Subject: Summary Status of GE/NRC March 4-6, 1991, Meeting on  
Plant Systems Open Items

SUMMARY STATUS OF GE/NRC MARCH 4-6, 1991 MEETING ON  
PLANT SYSTEMS OPEN ISSUES

ABWR HEAT REMOVAL SYSTEM

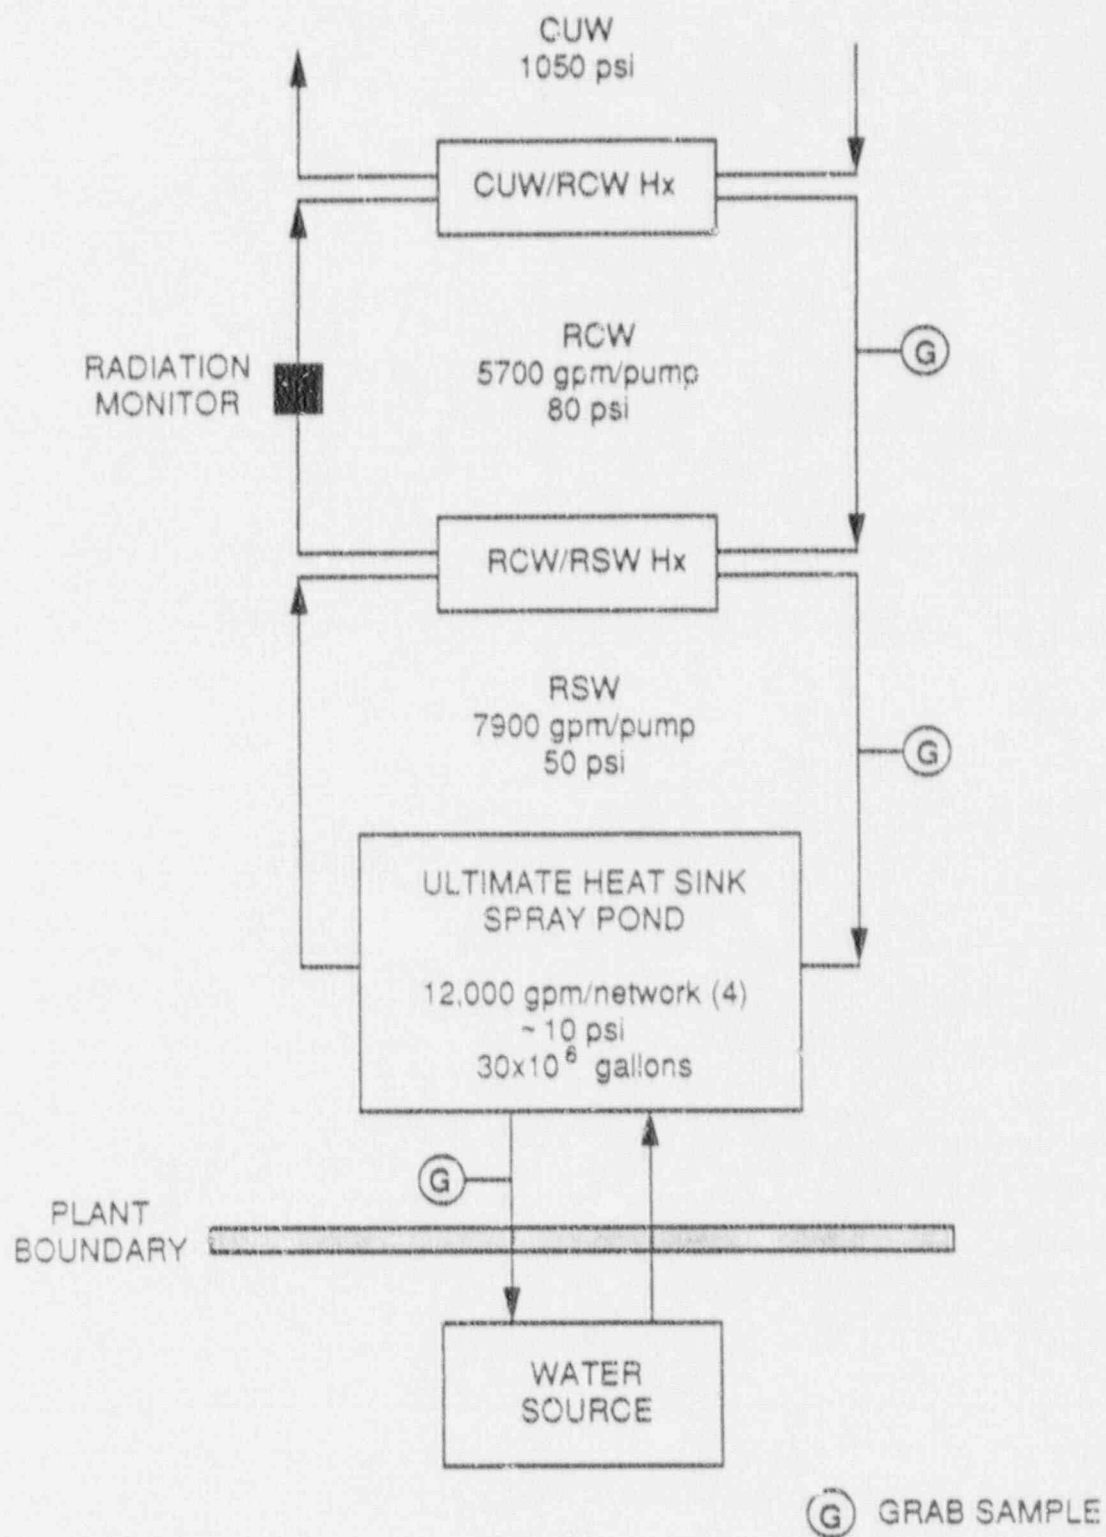
RESPONSE TO OPEN ITEM 11.5.1(1.C)

Continuous radiation monitors are not required for the three ABWR reactor service water (RSW) divisions for the following reasons.

As illustrated in the attached figure, heat is removed from systems, such as the reactor water cleanup (CUW) system, which potentially contain significant amounts of radioactive materials, by the reactor cooling water (RCW) system which is the intermediate loop. The heat in the RCW system is removed by the reactor service water (RSW) system, which then transfers that heat to the ultimate heat sink (UHS). Since the RSW system is not used to directly remove heat from any systems that normally contain radioactive materials, the passing of significant amounts of radioactive materials from a highly radioactive system to the UHS, requires two leaks present at the same time - (1) from the highly radioactive system into the RCW and then (2) from RCW to RSW (RCW is at the higher pressure).

If the first leak occurs, the continuous radiation monitor in the affected RCW division would alarm. The alarm set point of these monitors is set very low so that only a very small amount of radioactivity can enter the RCW system before alarm occurs. The following actions would be taken concurrently:

- (1) The operators would respond by sampling the RCW water to determine the leaking heat exchanger.
- (2) The affected RCW division would be taken out of service to minimize the spread of radioactivity.
- (3) In accordance with 10 CFR 20.106(d) and Reg. Guide 1.21, grab samples would be taken to determine if an abnormal release to an unrestricted area had occurred.

If the second leak occurs (water is flowing from RCW to RSW), the level will drop in the RCW surge tank. It will be automatically replaced by demineralized water from the makeup - water - purified (MUWP) system. There are flow meters in this makeup line to alert the operators that unusual makeup is occurring. During normal operation the RCW

system will be maintained in a low-leak condition. The surge tank is sized and the RCW system leak rate will be minimized to permit system operation during an accident for thirty days without makeup. Thus the allowable system leak rate from RCW to RSW will be kept low.

It is concluded that the intermediate loop, the RCW system, is an adequate barrier to the spread of radioactivity. The radiation monitors and grab sampling capabilities provided for the ABWR are adequate to detect any radioactive leaks before significant amounts are released to an unrestricted area. Therefore, continuous radiation monitors are not required in the RSW system.
